ARAMBURU & EUSTIS, LLP

May 23, 2014

Re: Bellevue Shoreline Master Program Update: Setbacks, buffers and Ordinary High Water Mark

Lineal Distance Between OHWM Locations

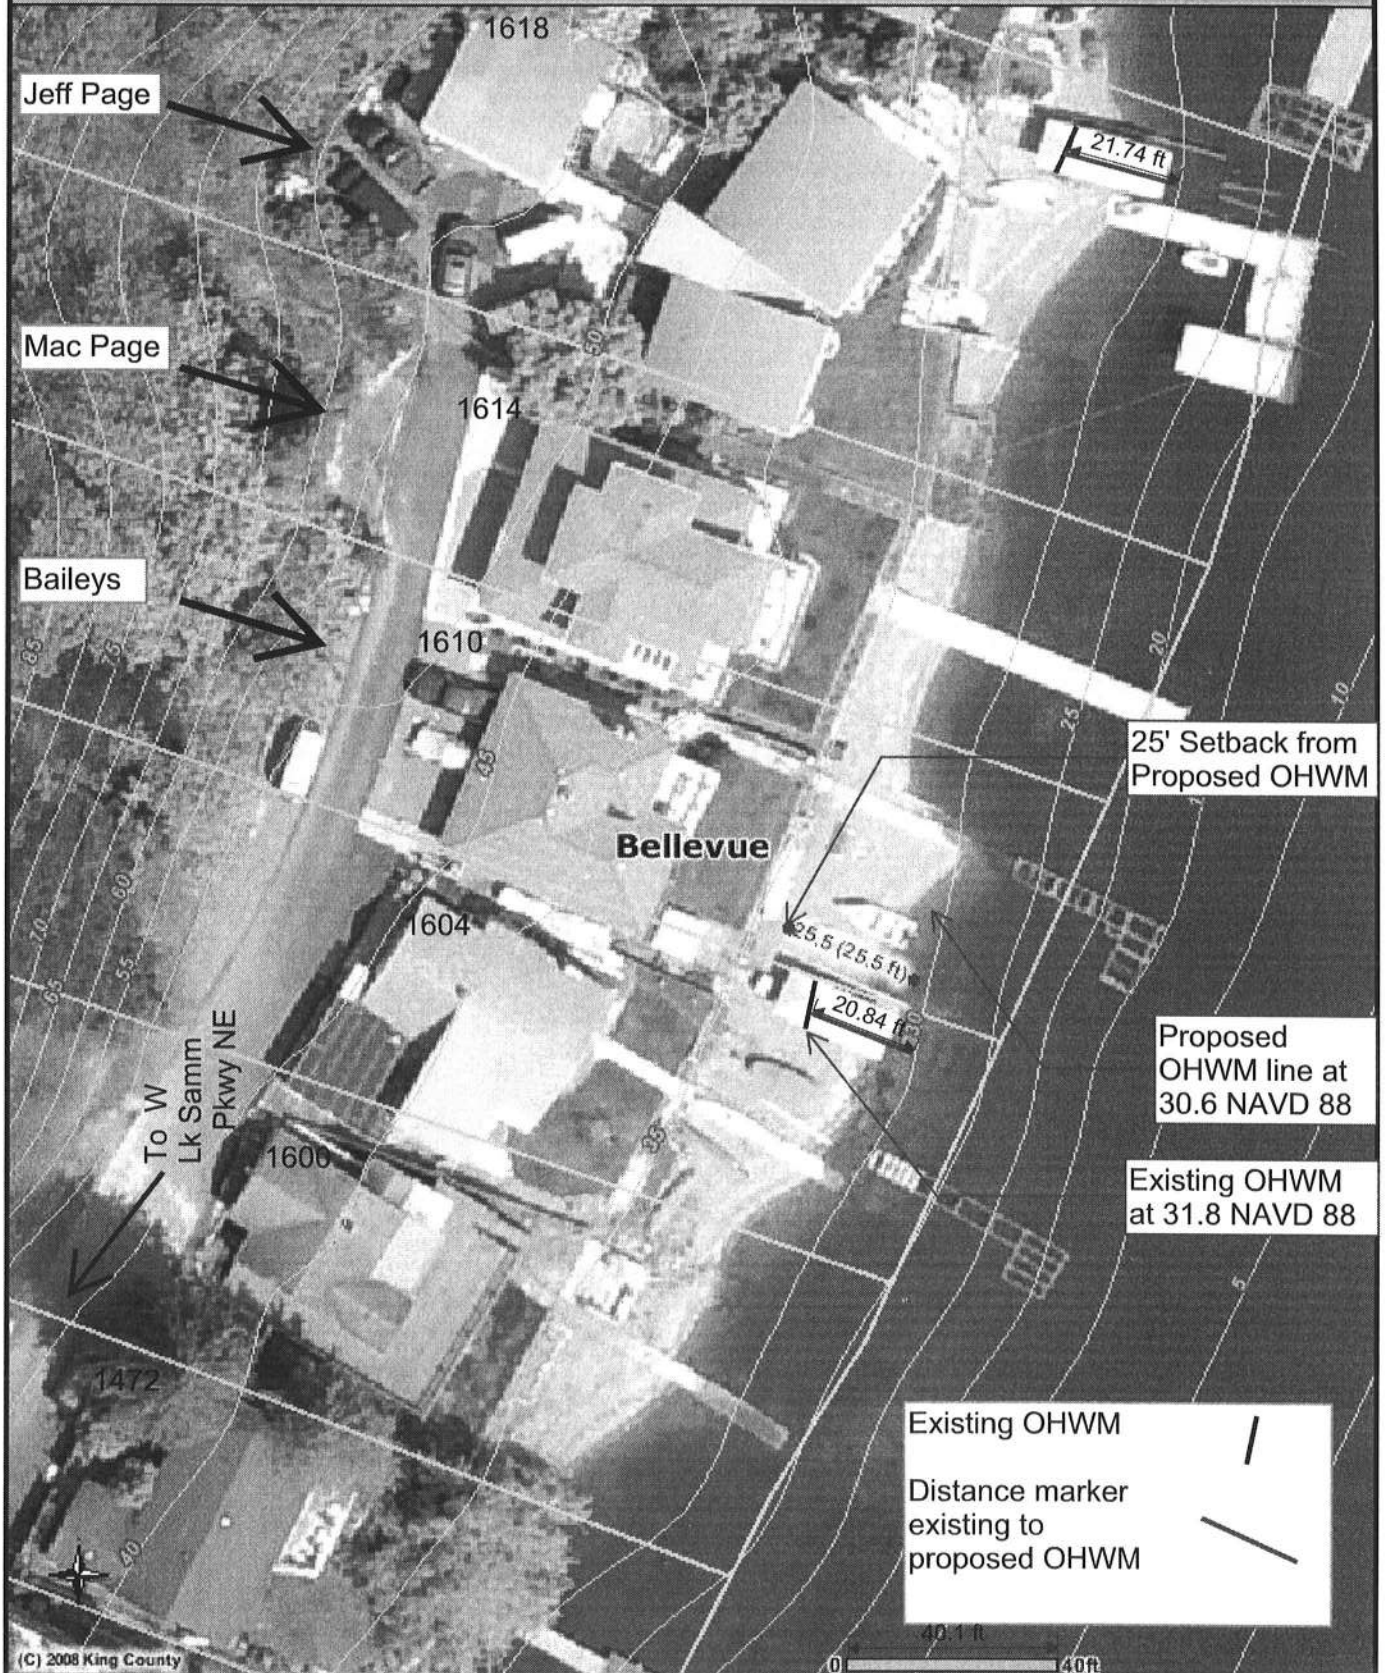
Though not a significant difference in vertical elevation, when the vertical rise is measured across a low, flat beach, the difference in the location of the OHWM becomes substantial. To illustrate the difference, we have charted the lineal difference between the two OHWMs on an actual stretch of Bellevue shoreline in Attachment A to this letter. The aerial photograph shows the Elevation 32 line now used by the City of Bellevue to measure setbacks taken from Bellevue mapping. This is compared to the 30.6 elevation shown on King County GIS mapping. (The Bellevue mapping does not include elevations below 32 feet because they are usually in the water). As noted on this attachment, the difference between the current OHWM and the proposed is about 20 feet. As also shown on the photograph, if the proposed 25 foot set back is measured from the new, and much lower, OHWM, residential building could extend onto the beach, an unanticipated and unintended consequence of planning commission review.

1. **ORDINARY HIGH WATER MARK.** The Council should establish the default OHWM at the existing 31.8 foot elevation (measured from the 32 foot contour). This elevation is supported by the scientific study of elevations previously prepared and used by other Lake Sammamish jurisdictions, while the planning commission recommendation is based primarily on anecdotal observations. In addition, by adopting an OHWM so far into the lake, the beginning point for setbacks is extended by as much as 20 feet. This would also increase the need for additional bulkheads in the lake.
